**ADDENDUM #1**

**Will County Health Department**  
**BID PACKAGE #3 – MEP/Finishes/Carpentry/Glazing**  
**November 30, 2018**

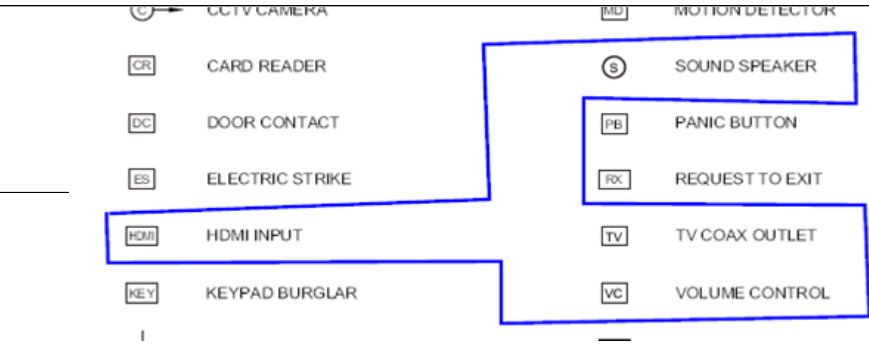
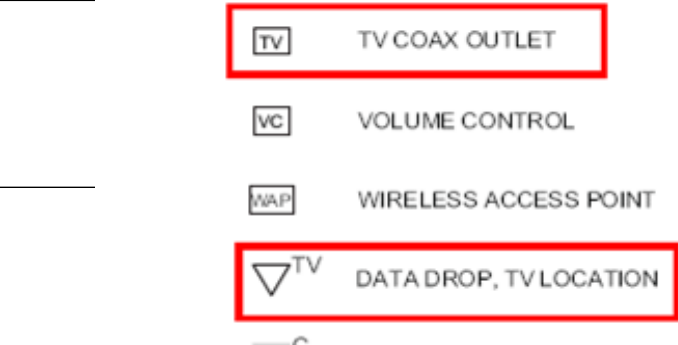
BP3-029		<p>Re: LED Alarm Lights;</p> <p>6. I couldn't find a device that matched this description on the Systems parts lists. Can you tell us what rough-in is required for this device?</p> <p>7. For break-out purposes, unless you tell us otherwise, we will include all of the outlets shown on T411-T422 (except as outlined below) as part of the Audio/Visual Rough-In.</p> 	7. OK	P
BP3-030	Addendum #1	<p>Re: HDMI Devices;</p> <p>8. Is there a special size conduit and back box requirement for each of these?</p>	Assume 1 1/2"	R
BP3-031	Addendum #1	<p>Re: Audio/Visual Speakers;</p> <p>9. Unless you tell us otherwise, we will assume that no rough-in is required for the ceiling speakers and that they will be installed by the A/V contractor.</p>	review drawings for clarification	R
BP3-032	Addendum #1	<p>Re: TV Outlets;</p> <p>10. The TV outlets on the Structured Cabling Drawings T311-T322 are duplicated on A/V Security Drawings T411-T422. Are these the same devices and should we assume that only one conduit stub is required as shown on T311-T322 or are two stubs required?</p> <p>11. Per the A/V Contractors Scope of work there may be special backboxes required</p> <p>Can you specify a type to be furnished so we can labor them out properly? Otherwise we will furnish 1G backboxes with 3/4" conduit stubs only, one for Data, and a separate one for A/V. (See the Attachment)</p> <p>12. Should these Outlets be included as part of the A/V Breakout on the Bid Form?</p> 	10. Assume 2 11. Provide only what is specified 12. OK	R
